Remarks

Summary

Claims 1, 3, 5, and 8-10 have been amended, claim 2 has been cancelled, and new claims 11-18 have been added. Claims 1, and 3-18 are pending for consideration.

Fig. 11
(Prior Art)

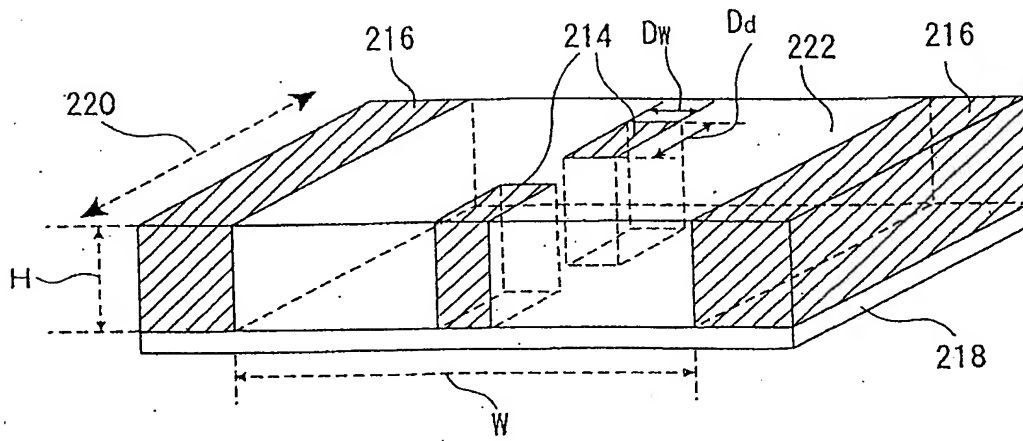
The Office Action objected to Figs. 10 and 11 for failing to include a legend indicating that the figures are "Prior Art". As shown in the attached replacements sheets for Figs 10 and 11, these figures now include the legend - - (Prior Art) - - . Marked-up copies of Figs 10 and 11 showing the changes in red are also attached.
